Agenda Item # 5 - HOLDOVER

SUB-003838-2026, MOD-003841-2026 & MOD-03842-2026

50 & 60 South Ann Street

APPLICATION NUMBER	5	DATE	October 15, 2026
APPLICANT	Third Annunciation Greek Orthodox Church		
REQUEST	Subdivision, PA Modification, PUD Modification

SUBDIVISION SITE PLAN

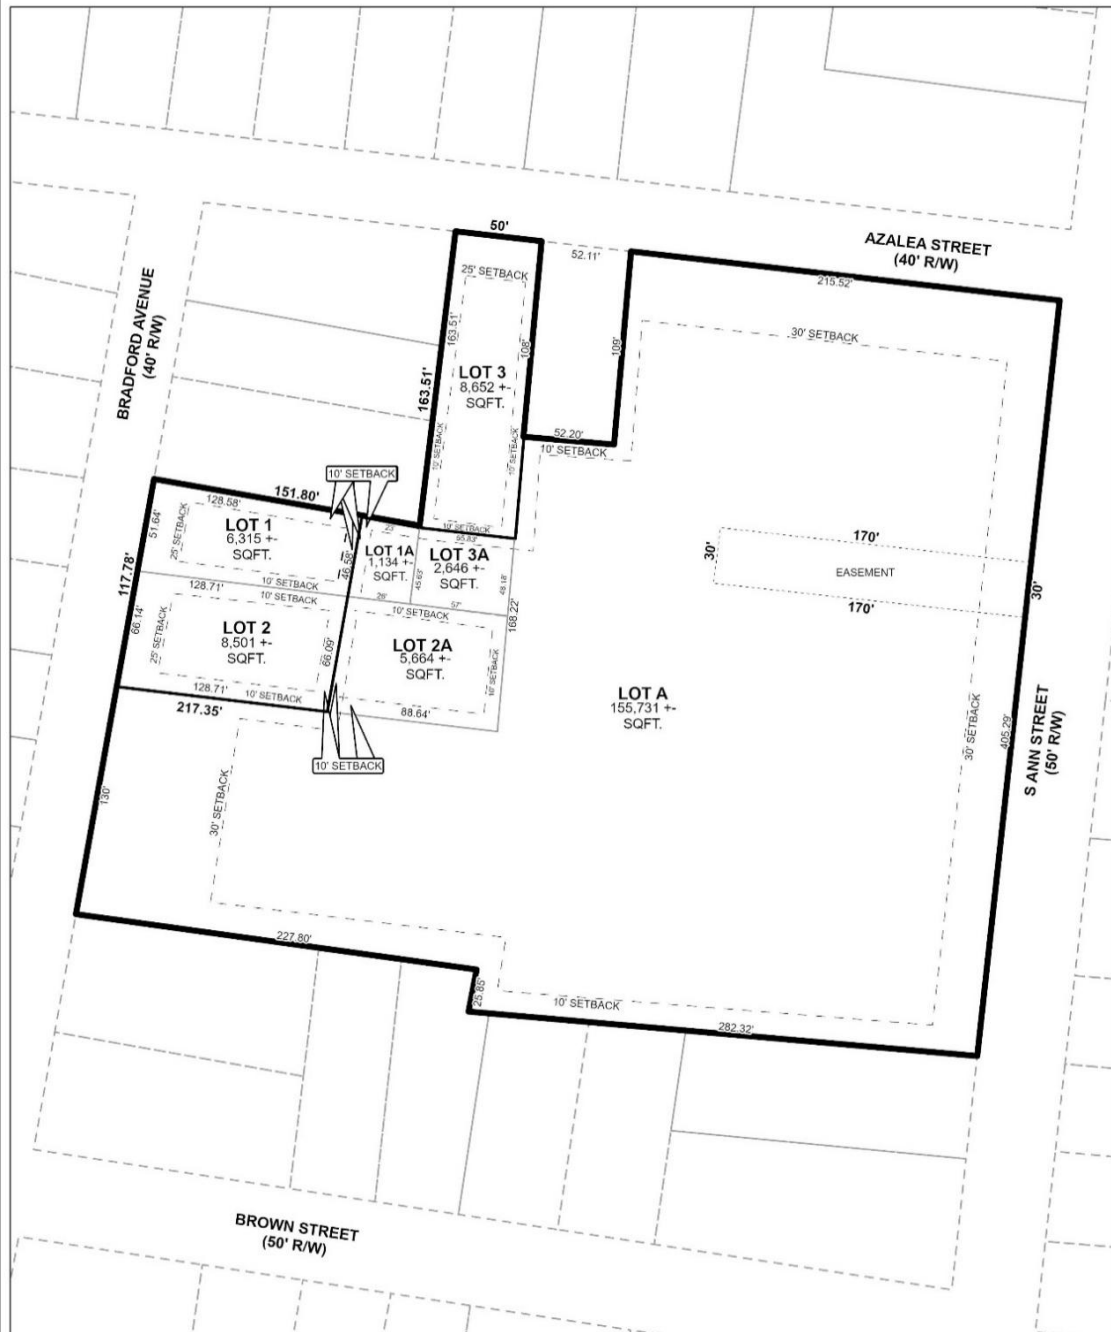
As shown on the recorded plat of *Annunciation Greek Orthodox Church Subdivision*, the preliminary plat retains the 25-foot minimum building setback line along Ann Street and 30-foot setbacks along Azalea Street and Bradford Avenue. However, the site is located within the Old Dauphin Way Historic District Overlay (HDO), which requires front yard setbacks to be no greater or lesser than the setback of those structures located on the same side of the street within 150 feet, exclusive of the right-of-way, on either side of the proposed building site. Therefore, the plat should be revised to remove the previously recorded setbacks associated with the *Annunciation Greek Orthodox Church Subdivision*. If approved, a note should be placed on the Final Plat stating

The preliminary plat also illustrates 10-foot side and rear yard setbacks along the interior lot lines. These setbacks should be removed from the Final Plat, if approved.

If approved, the lot area should be labeled on the Final Plat in both square feet and acres. Alternatively, a table providing the same information may be included on the Final Plat.

As with the Final Plat of Annunciation Greek Orthodox Church Subdivision, a note should be included on the Final Plat, if approved, denying access to Bradford Avenue.

Finally, approval from the Historic Development Department is required prior to the issuance of any development permits. If approved, a note stating this requirement should be placed on the Final Plat.

1. Approval and recording of the *Second Annunciation Greek Orthodox Church Subdivision* prior to signing the Final Plat;
2. Retention of the existing right-of-way width labels for all streets on the Final Plat;

3. Revision of the plat to remove the previously recorded minimum building setback lines along all street frontages, and placement of a note on the Final Plat stating that the site shall comply with the provisions of the Historic District Overlay (HDO) in Article 14 of the UDC, including the applicable front, rear, and side yard dimensional standards for lots within the HDO;

4. Revision of the plat to remove the 10-foot side and rear yard setback lines from the Final Plat;
5. Retention of the lot area label, in both square feet and acres, on the Final Plat, or provision of a table on the Final Plat providing the same information;

6. Placement of a note on the Final Plat stating that access to Bradford Avenue is denied;
7. Placement of a note on the Final Plat stating that approval from the Historic Development Department is required prior to the issuance of any development permits;

MODIFICATION SITE PLAN

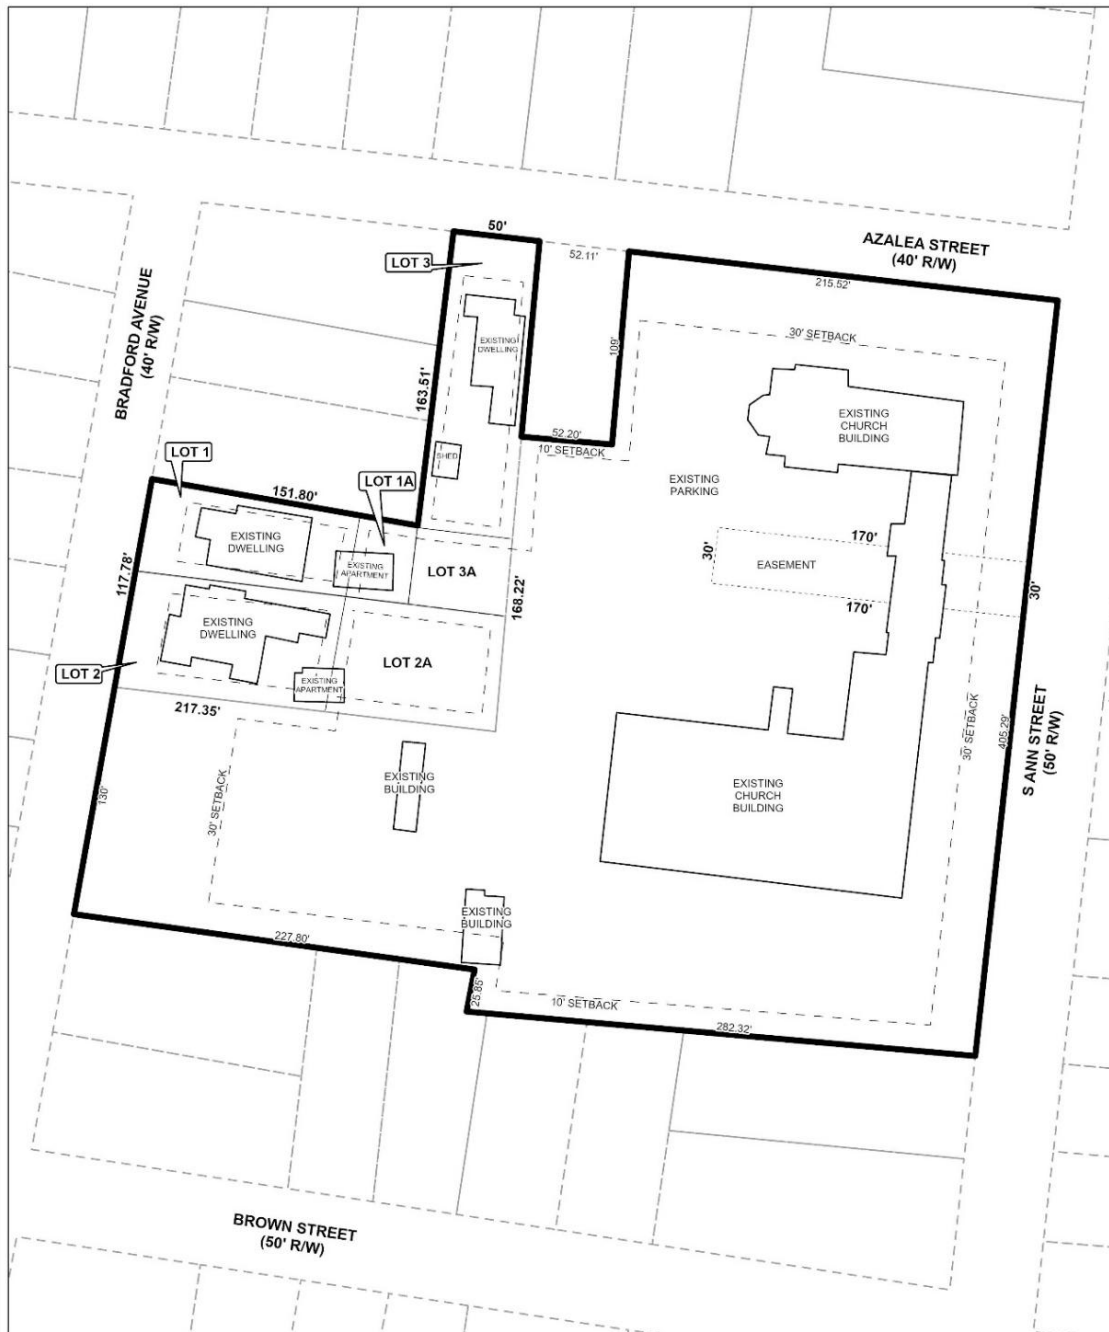
The submitted site plans indicate the right-of-way widths of all streets. These right-of-way widths should be retained on the recorded site plans, if approved.

The site plans also depict existing buildings within the proposed Modification area, including buildings proposed to be demolished as part of the *Second Annunciation Greek Orthodox Church Subdivision*. As these buildings will no longer exist, the site plans should be revised to remove them, as they cannot be considered as part of the proposed Modifications.

The site plans indicate the setbacks shown on the preliminary plat for the main church site, but do not indicate setbacks on the other portions of the proposed Modification area. However, the site is located within the Old Dauphin Way Historic District Overlay (HDO), which limits front yard setbacks to no greater or lesser than the setback of those structures located on the same side of the street within 150 feet, exclusive of the right-of-way, on either side of the proposed building site. Therefore, the site plans should be revised to remove the front minimum building setback lines from all street frontages. A note should also be placed on the site plans stating that the site shall comply with the provisions of the Historic District Overlay (HDO) in Article 14 of the UDC, including the applicable front, rear, and side yard dimensional standards for lots within the HDO.

The site plans should be revised to provide an overall site area label. Alternatively, a table providing the overall site area may be included on the site plans.

The site plans do not depict sidewalks along the street frontages and should be revised to illustrate all existing sidewalks. No dumpster is shown on the site plans. The site plans should be revised to indicate a compliant

dumpster, or a note should be placed on the site plans stating that no dumpster will be utilized and that refuse collection will be provided through either curbside pickup or a private can collection service.

The site is abutted to the north, west, and south by properties zoned R-1, Single-Family Residential Urban District. If approved, the site plans should be revised to clearly depict a compliant residential buffer wherever the site abuts residentially zoned or residentially utilized property. Alternatively, a note should be placed on the site plans stating that compliant buffers will be provided where required.

As with the *Third Annunciation Greek Orthodox Church Subdivision*, a note should be included on the site plans stating that access to Bradford Avenue is denied.

The site is located within the Old Dauphin Way Historic District. Therefore, a note should be placed on the site plans stating that approval from the Historic Development Department is required prior to the issuance of any development permits.

1. Retention of the existing right-of-way width labels for all streets on the site plans;
2. Revision of the site plans to remove the buildings proposed to be demolished in conjunction with the approval of the *Second Annunciation Greek Orthodox Church Subdivision*;
3. Revision of the site plans to remove the illustrated minimum building setback lines along all street frontages, and placement of a note on the site plans stating that the site shall comply with the provisions of the Historic District Overlay (HDO) in Article 14 of the UDC, including the applicable front, rear, and side yard dimensional standards for lots within the HDO;
4. Revision of the site plans to provide an overall site area label, or provision of a table on the site plans providing the same information;

5. Revision of the site plans to depict existing public sidewalks along all street frontages;
6. Revision of the site plans to indicate a compliant dumpster, or placement of a note on the site plans stating that no dumpster will be utilized and that refuse collection will be provided through either curbside pickup or a private can collection service;

7. Placement of a note on the site plans stating that access to Bradford Avenue is denied for the portion of the site located within the *Third Annunciation Greek Orthodox Church Subdivision*;

8. Revision of the site plans to clearly depict a compliant residential buffer where the site abuts residentially zoned or utilized property, or placement of a note on the site plans stating that compliant buffers will be provided where required;

9. Placement of a note on the revised site plans stating the Traffic Engineering comments noted in this staff report;
10. Placement of a note on the site plans stating that approval from the Historic Development Department is required prior to the issuance of any development permits;
